Migrating from the LAN9118 to the LAN9218I

1 Objective

Figure 2.1 Transmit Circuit

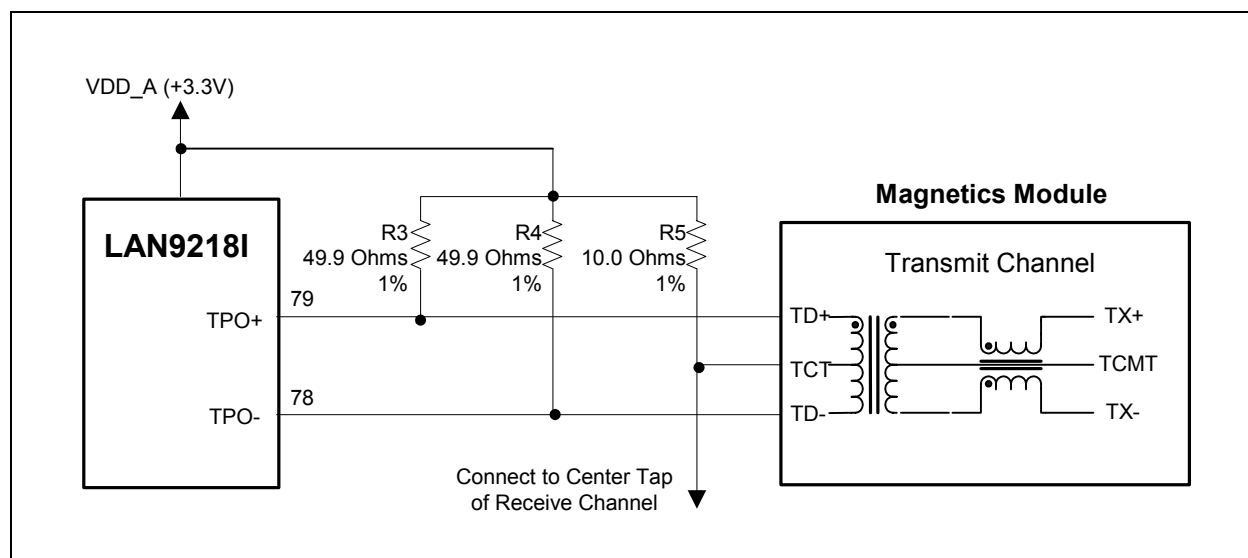
There are only two differences between the transmit circuit for the LAN9218I and the one previously used for the LAN9118:

- The LAN9218I uses magnetics that support HP Auto-MDIX.
- The device-side center tap of the transmit core (TCT) is attached to the device-side center-tap of the receive (RCT).

- A 49.9 ohm, 1% resistor from each side of the twisted pair to VDD_A (+3.3V)
- A 10 ohm, 1% resistor from the transmit center tap to VDD_A (+3.3V).

Figure 2.2 Receive Circuit

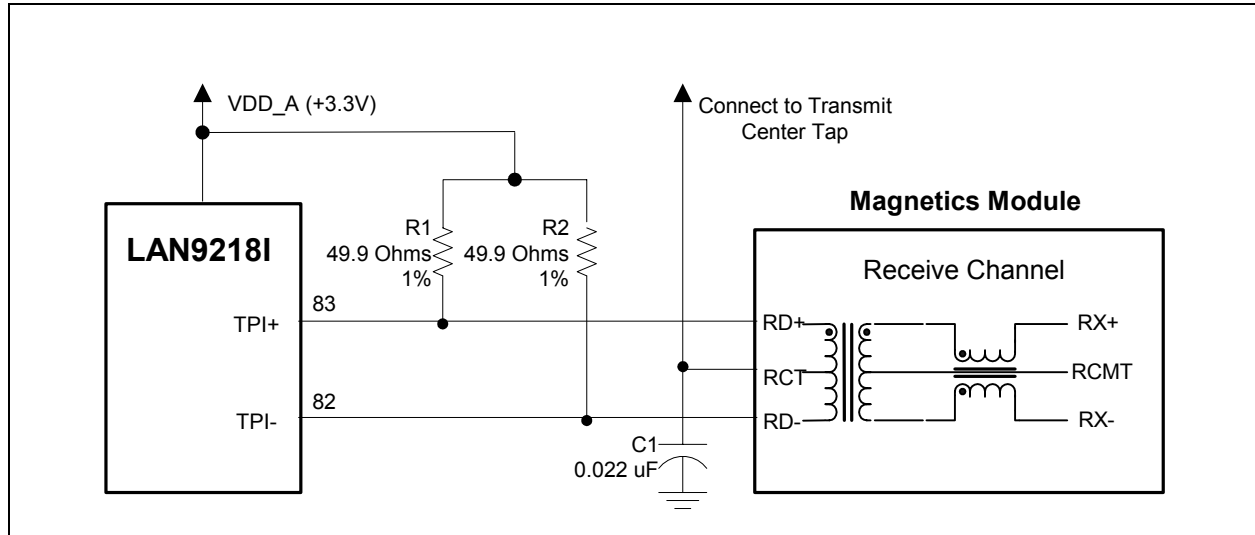
The differences between the LAN9218I and the LAN9118 are as follows:

- The LAN9118 had two 6.8nf capacitors, one in series with each side of the twisted pair, in the LAN9218I these are eliminated (shorted).
- In the LAN9118, the mid-point between the two 49.9 ohm resistors is tied to the center tap of the magnetics (RCT) and to a .01uF bypass capacitor to ground. In the LAN9218I, both resistors are tied to VDD_A (+3.3V). The .01uF bypass capacitor is eliminated. The center-tap of the receive channel of the magnetics is tied to the transmit center tap (TCT) and to a common 0.022uF bypass capacitor to ground.
